## 00/300 AREA UNIT MANAGER MEETING

100/300 AREA UNIT MANAGERS MEETING  
APPROVAL OF MEETING MINUTES  
January 8, 2009

**Agreement:** Attachment 10 (narrative), Attachment 11 (excel table with proposed sampling changes), and Attachment 12 (maps showing location of sampling points in Attachment 11) are proposed changes to the *Remedial Investigation Work Plan for Hanford Site Releases to the Columbia River*, DOE/RL-2008-11, Rev. 0. RL, EPA, and Ecology approve the proposed changes as outlined in these three attachments.

Figure 2-4

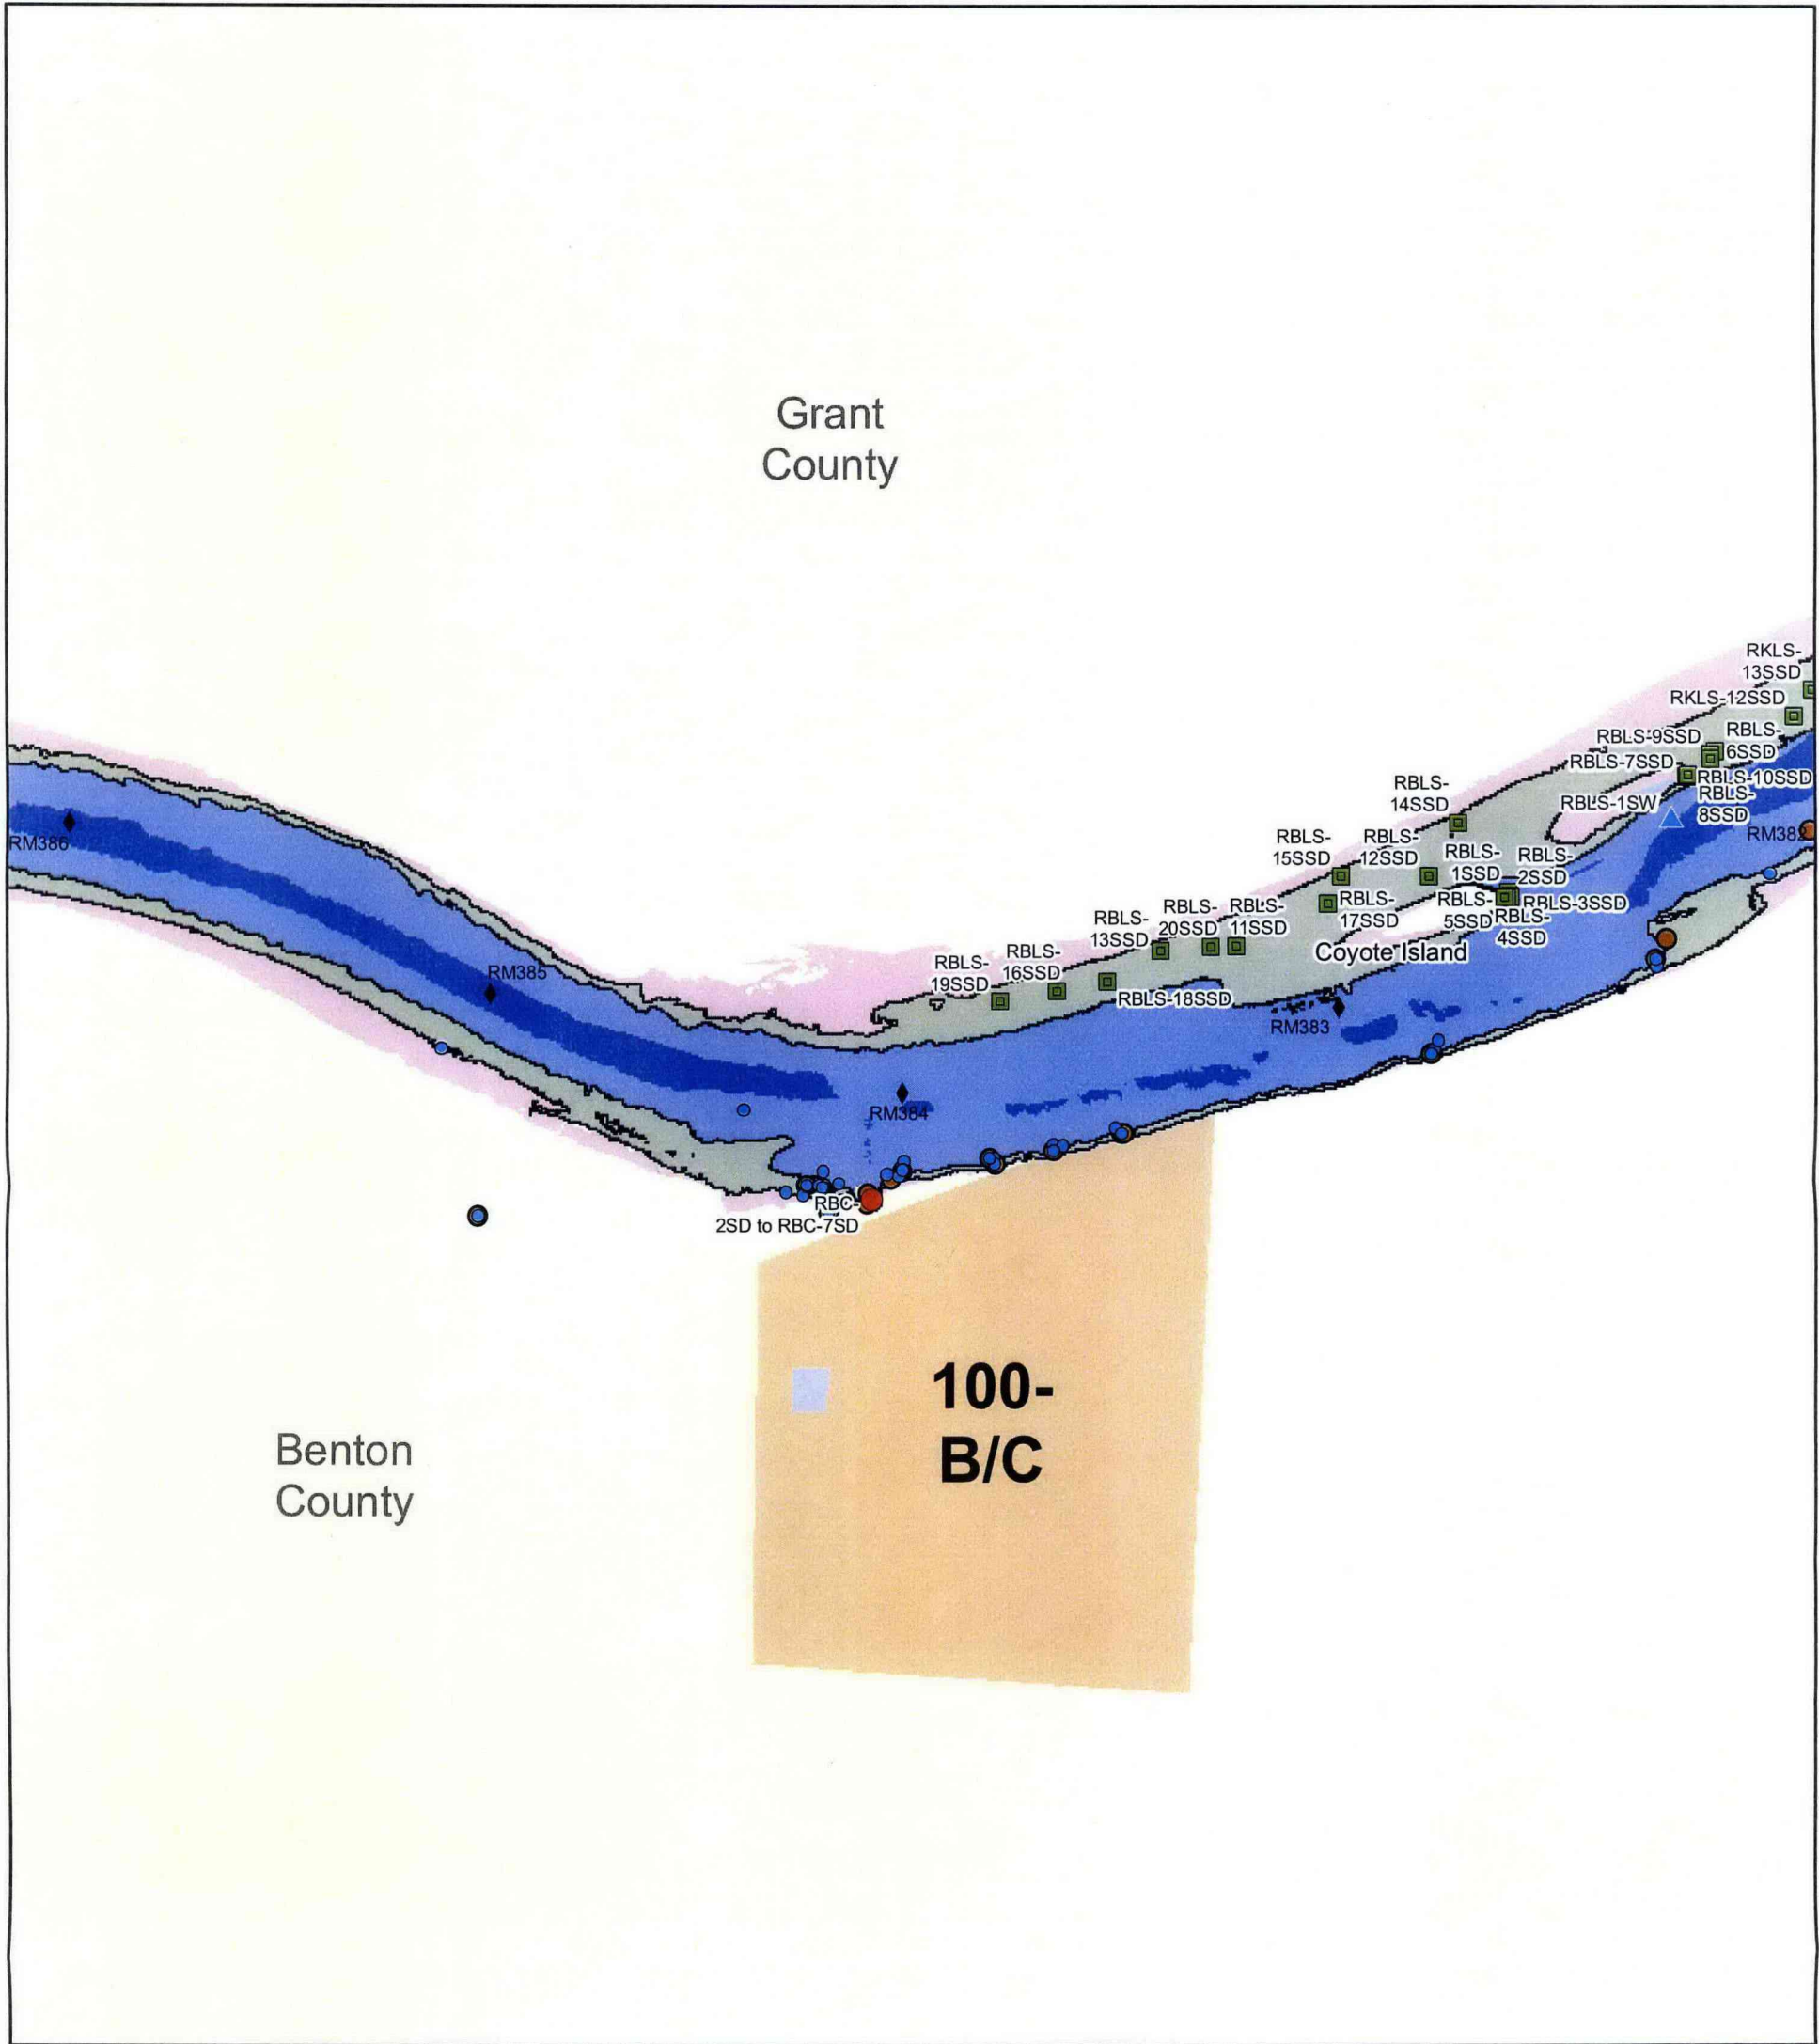
Figure 2-4	Reactor Area	Sediment, Shoreline	Grab	Reactor B Left Side Shoreline Sediment	RBLS-11SSD to RBLS-20SSD	All New	-	-	-	Change from shallow Sed to Shoreline	10	Random/Stratified	0 - 0.3 ft	Relocate and changed to shoreline sediment samples
Figure 2-4	Reactor Area	Sediment, Deep	Ponar	Reactor B Trench	RB-6SD	No Sediment	-	All	1	-	-	Random/Stratified	0 - 0.3 ft	One deep sediment sample will be taken from 100-B/C Hole. The upper 4 inches will be used for evaluating ecological impacts.
Figure 2-4	Reactor Area	Surface Water	Grab	Reactor B Left Side Slough Surface Water	RBLS-1SW	Limited	All	-	-	-	-	Random/Stratified	2/3 surface water depth	One SW sample will be collected from far shore to augment near shore RCBRA SW sampling.
Figure 2-4	Reactor Area	Fish <sup>2</sup>	See Note 1	100BC Hole	RB-FS1 to RB-FS5	Opportunistic	On-Site	-	-	-	-	Focused	NA	Fish samples will be collected from the 100-B/C Hole. Number and type of fish may vary depending on availability of fish at time of sampling.

Figure 2-4	Reactor Area	Core, Shallow (2-inch diameter)	Vibracore	Reactor B Inlet Structures	RBC-1SD to RBC-6SD (1 core location subdivided. into approx. 6 sed. samples) <sup>4</sup>	Opportunistic	On-Site	-	-	-	-	Focused	0 - Refusal (1 ft subsamples)	One core will be completed within the water intake trench/structure. Samples will be divided into 6 one foot samples (2-in core = ~ 600 gms per 1 foot). Evaluate historic deposition of Hanford contaminants (e.g., sediment trap).
Figure 2-5	Reactor Area	Pore Water, GU	Grab	Reactor K GW Plume	RK-1PW to RK-6PW <sup>7</sup>	Opportunistic	On-Site	-	-	-	-	Focused	1 ft below mudline	Focus to characterize GW plume discharge to river. Major use will be ecological impacts. Five samples are budgeted; the actual number will depend on results of pore water sampling in the hyporheic zone adjacent to reactor area.

Figure 2-7

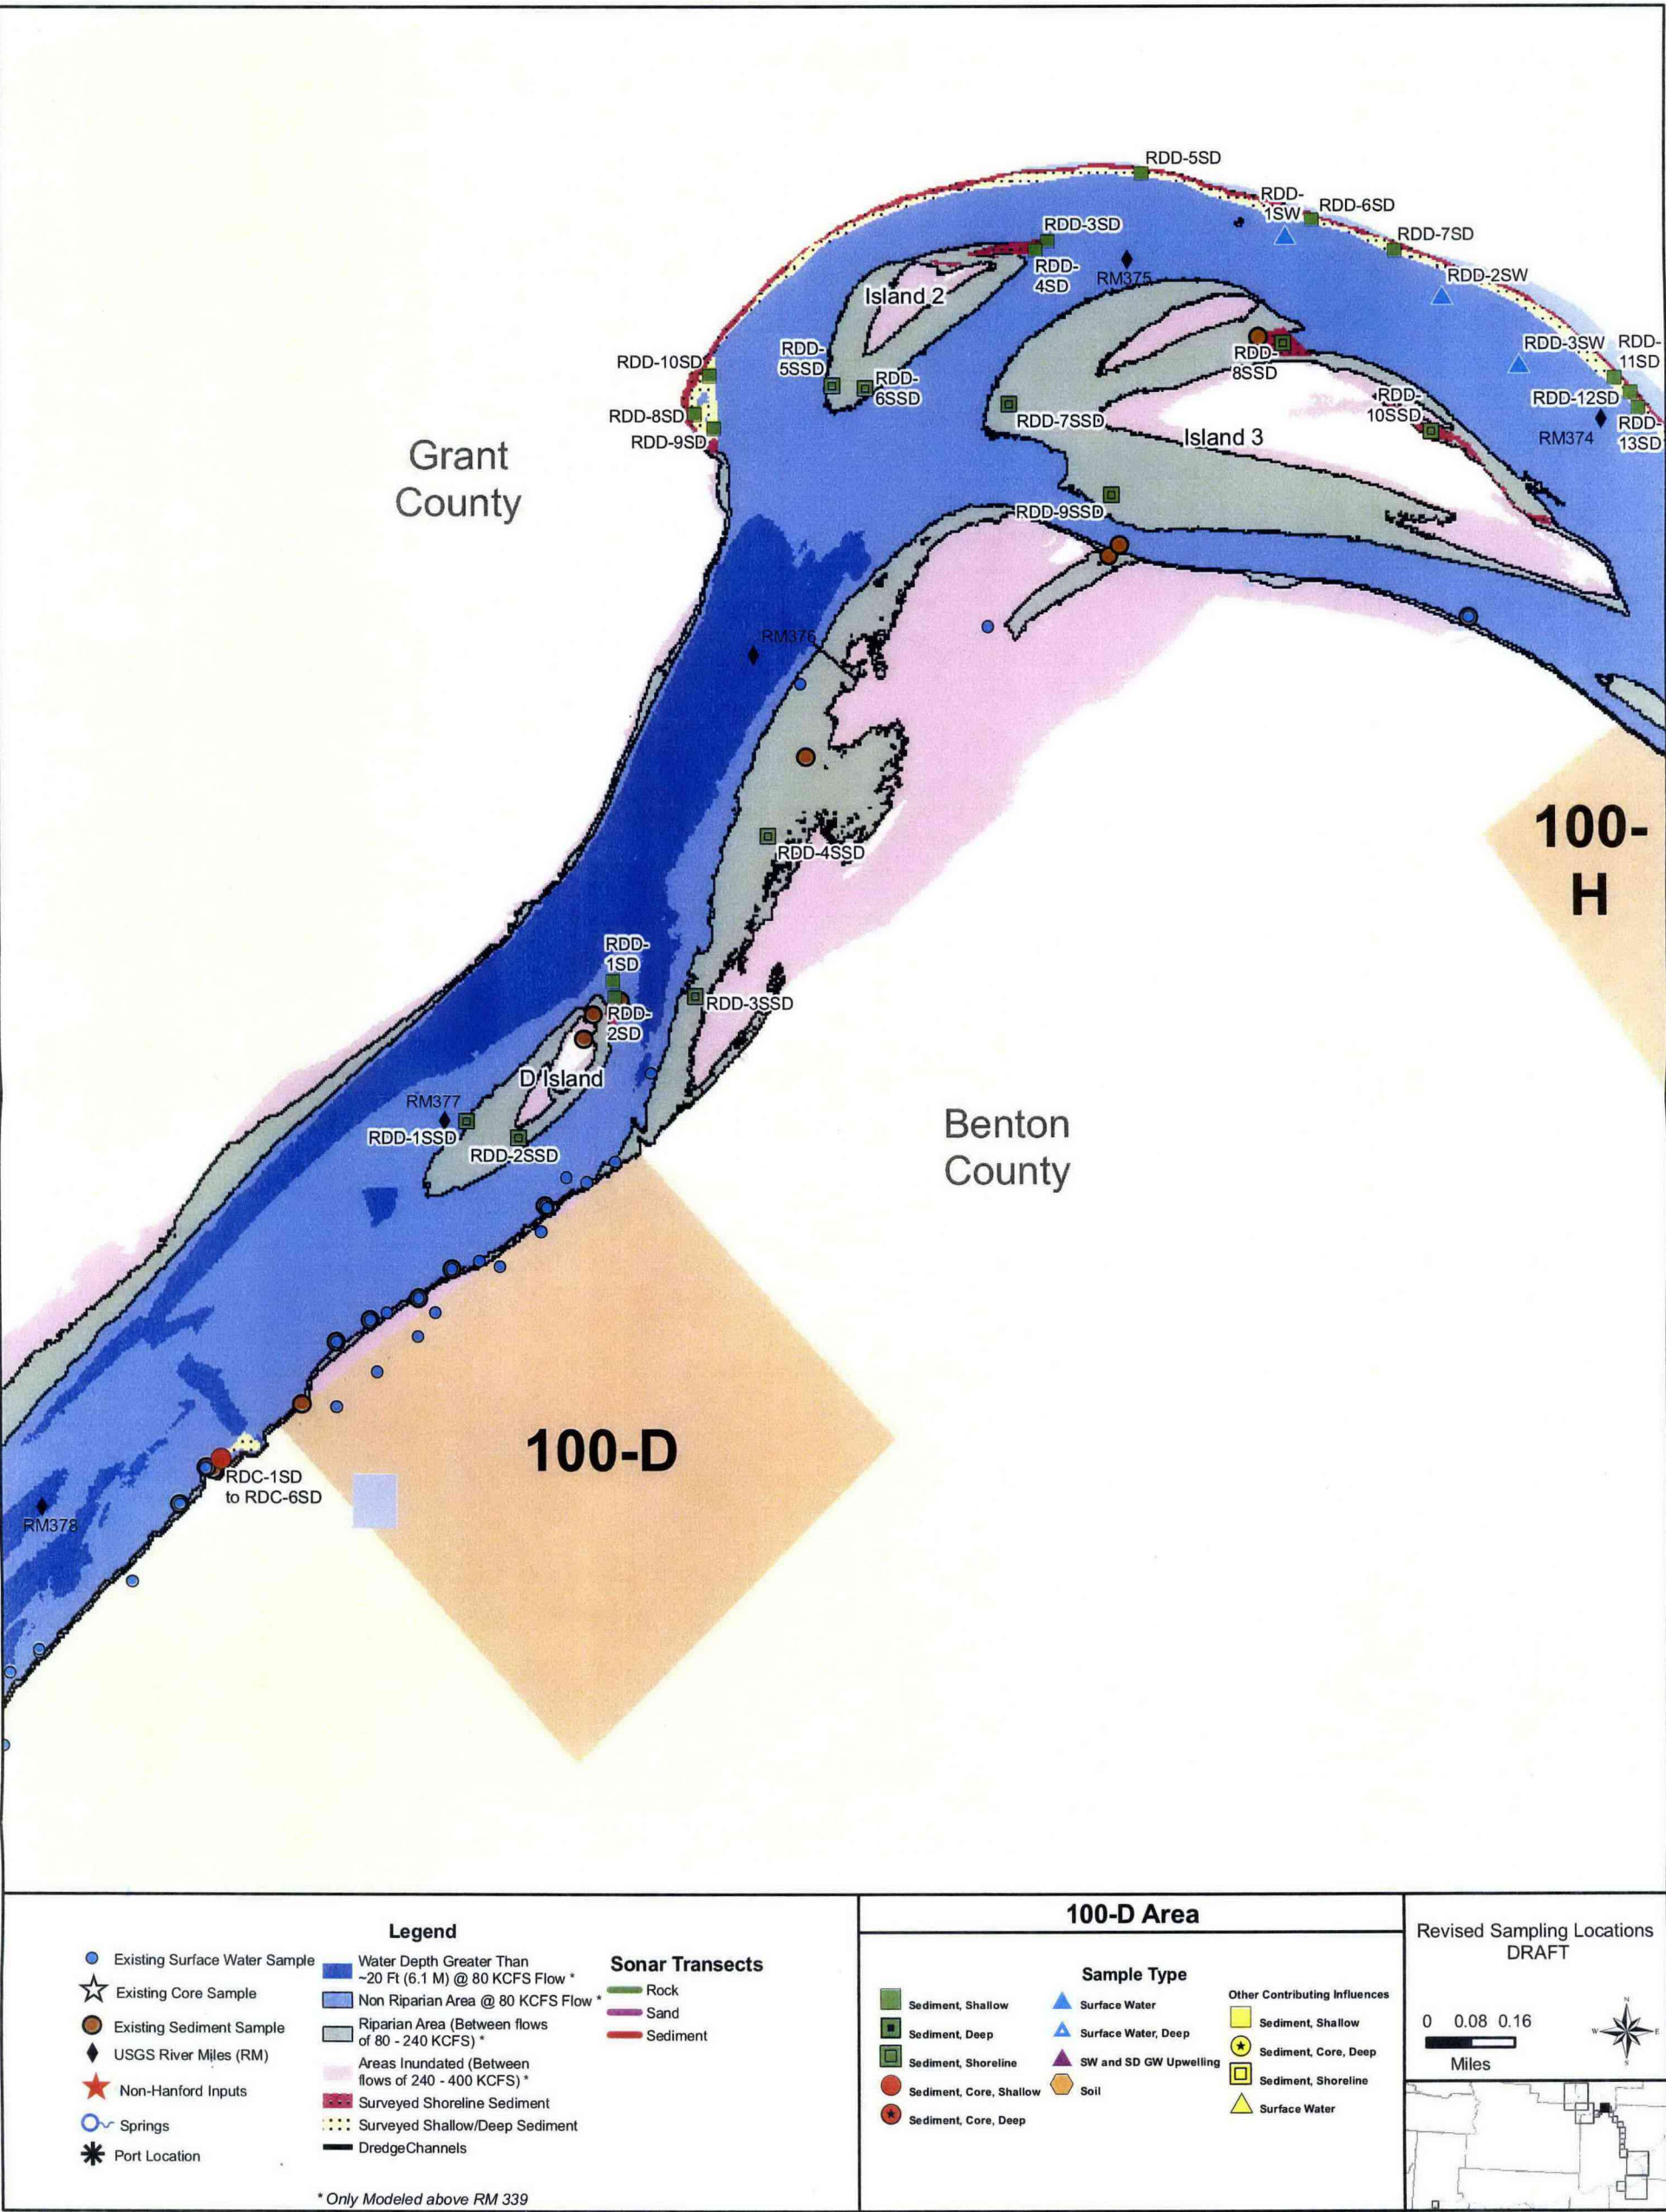
Figure 2-7	Reactor Area	Sediment, Shallow	Ponar	Reactor D downriver Sediment	RDD-11SD to RDD-14SD	Limited Sediment	-	RDD-15 to RDD-20	6	-	-	Random/Stratified	0 - 0.3 ft	Based on sonar survey results, ten samples will be collected on the far (left) shore across from Island 3 and in the shore area of WB Hole 1
Figure 2-7	Reactor Area	Sediment, Shoreline	Grab	Reactor D downriver Shoreline Sediment	RDD-1SSD to RDD-10SSD	Limited	All	-	-	-	-	Random/Stratified.	0 - 0.3 ft	Based on an ecological habitat survey, ten samples will be collected. Two samples will be collected from the shallow area upriver and adjacent to D Island; two more samples will be collected from the shallow area on the near shore (right) downriver from D Island; two samples will be collected from the shallow area upriver and adjacent to Island 2; the remaining samples will be collected upriver and adjacent to Island 3 on the near shore side.
